KINGSTON SOLAR LP

Sol-Luce Kingston Solar PV Energy Project

MODIFICATIONS DOCUMENT

Figure 1: Property Boundary of the Project Location and New Lands

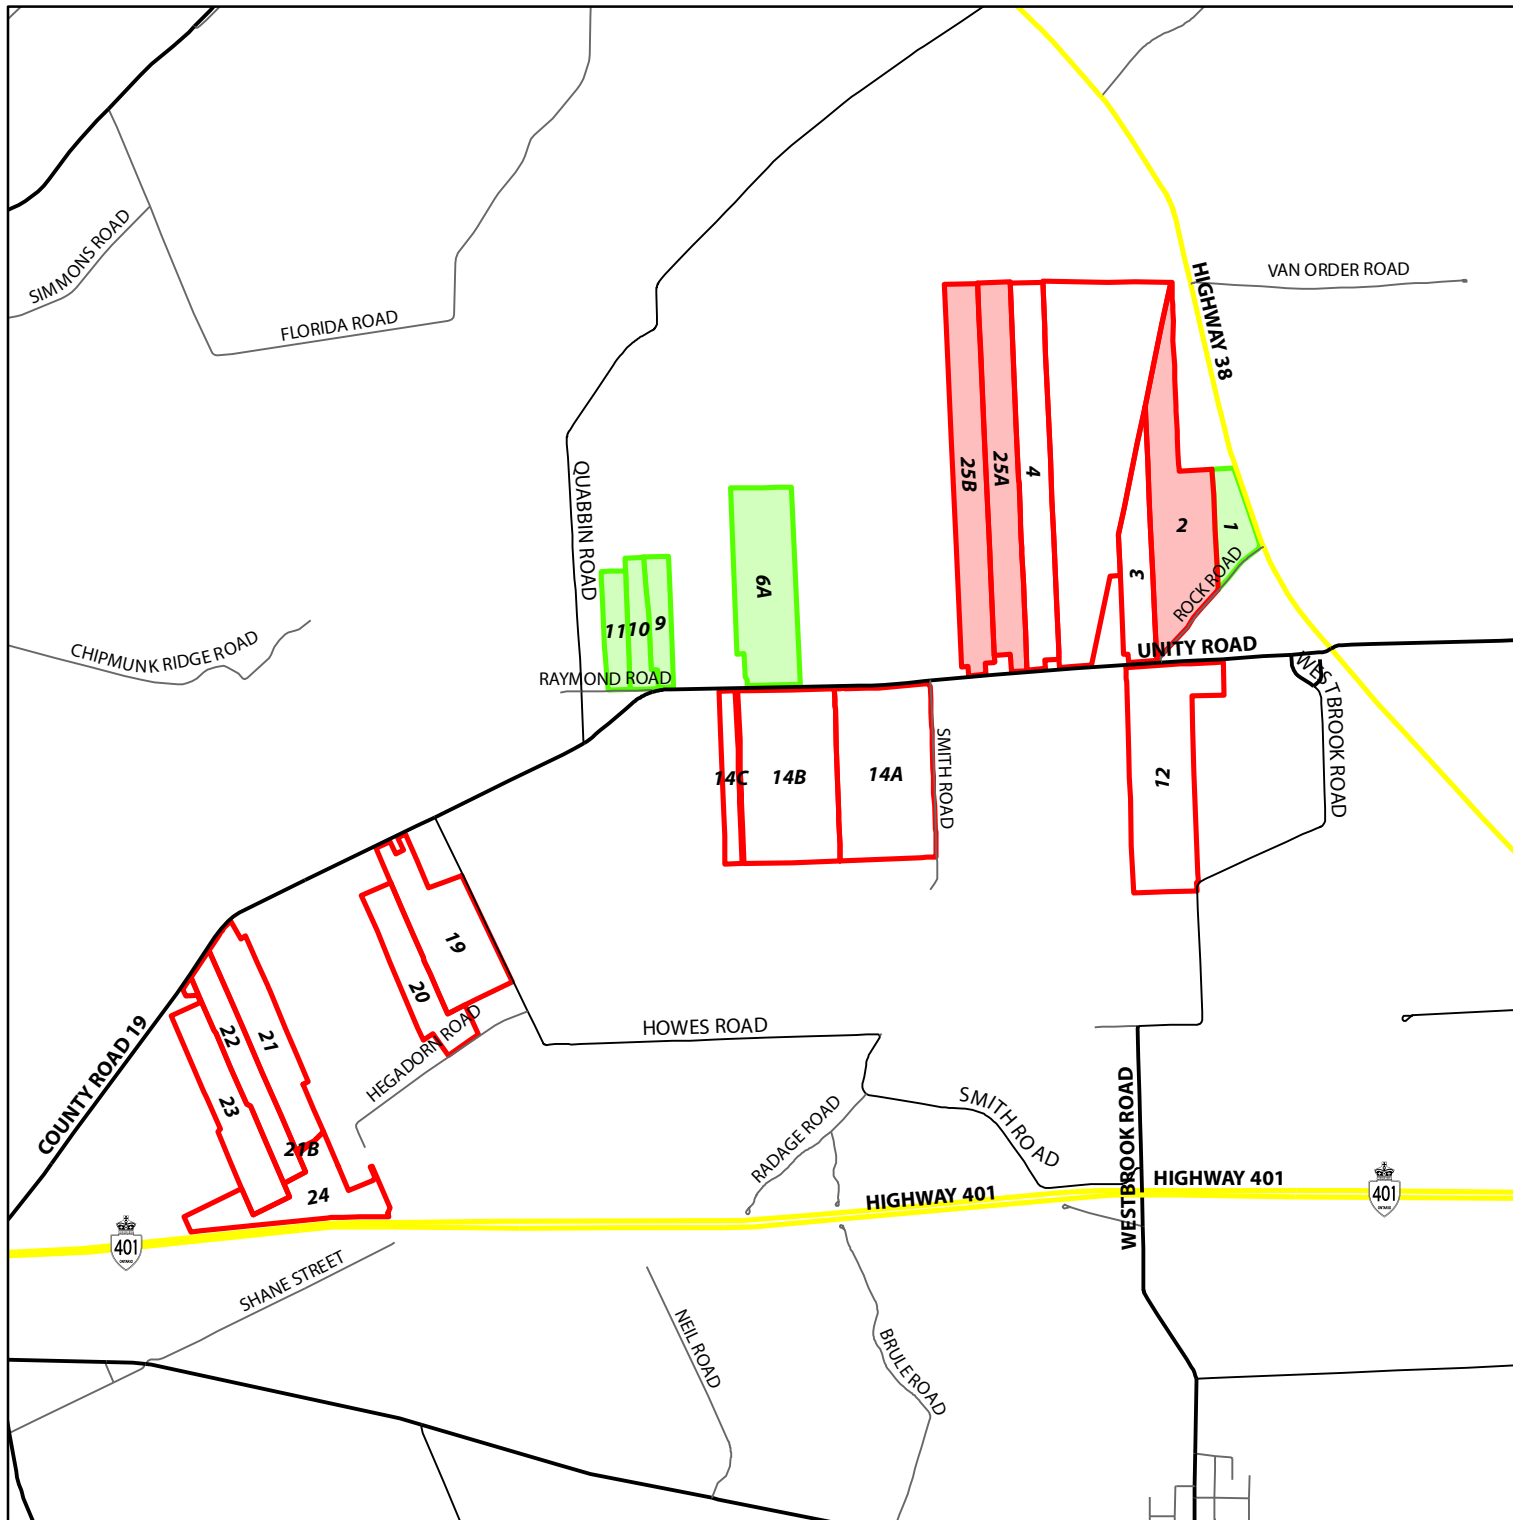
In May 2012, the City of Kingston released a document entitled “Landscaping and Site Design Guidelines for Large-Scale, Ground-Oriented Solar Energy Facilities”, which outlined their standards with respect to mitigating visual impacts from proposed solar facilities. On September 11 2013, Kingston Solar LP met with Loyalist Township’s representatives to provide a project update, and informed the municipality about Kingston Solar LP’s initiative to undergo an REA amendment. During the meeting both parties agreed that the same setback guidelines requested by the City of Kingston must be implemented on the participating properties located under Loyalist Township’s jurisdiction. Due to the setback requirements requested by the municipalities, Kingston Solar LP is proposing to reallocate a number of project related components to new lands and implement the requested setbacks across the balance of the project location. The project location was adjusted by eliminating some of the existing lands and adding new lands as indicated in Figure 1 and 2.

In addition to the proposed changes to the project location lands described in Section 3.0 and depicted on Figure 1, Kingston Solar LP is proposing the following technical changes to the application:

As new lands have been added to the project, Stage 1 and 2 Archaeological Assessments (AA1, AA2) were undertaken for the amended project location (See Figure 1, new lands as part of the amended project location are identified as Properties #2, 25A, and 25B) in October 2013 by Stantec Consulting. An archaeological report was submitted to the MTCS on October 23, 2013; the assessment concluded that no further archaeological assessment is required on the new lands. Subsequently the MTCS provided a compliance letter on October 25, 2013 (Appendix B). The full Stage 1 & 2 Archaeological Assessment Report completed by Stantec is provided in Appendix F.
